Dealer  
Technical  
Bulletin

Subject: IGNITION TIMING AND IDLE SPEED CHANGES  
REF. 68-T-2

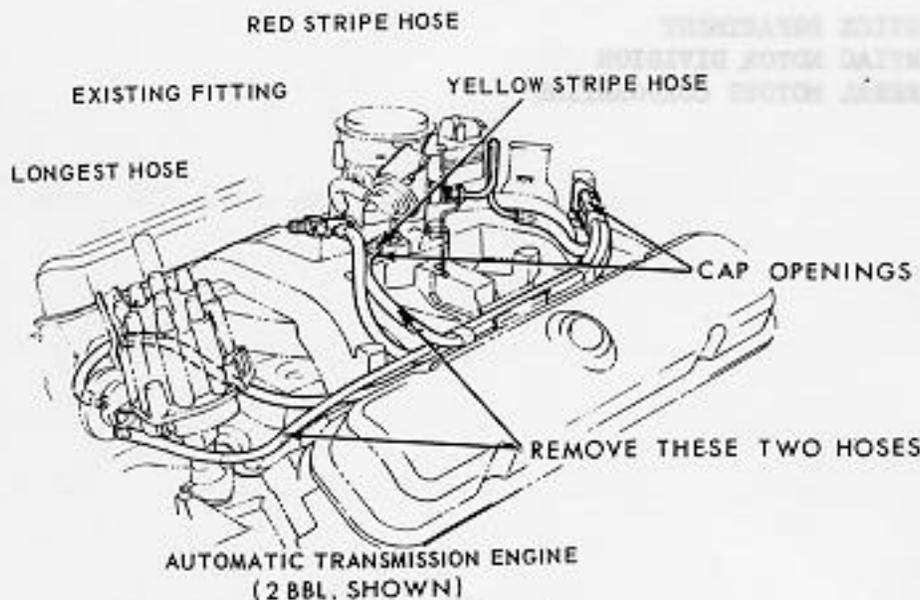
This bulletin is intended to clarify the procedure involved in changing ignition timing and idle speed settings on certain 1968 vehicles as outlined in Dealer Technical Bulletin 68-T-2.

The figure below indicates the vacuum hoses to be removed during this operation. For the necessary additional information, consult Section 2 of the above mentioned bulletin.

NOTE: After readjusting idle speed on 4-bbl. engines, it is important that the fast idle speed also be checked and adjusted if necessary. When set to proper specifications, the possibility of loading up during cold starts is greatly alleviated.

After performing the rework as noted, the tune-up label should be replaced by a new one reflecting the changes. The new labels listed below are now available for service.
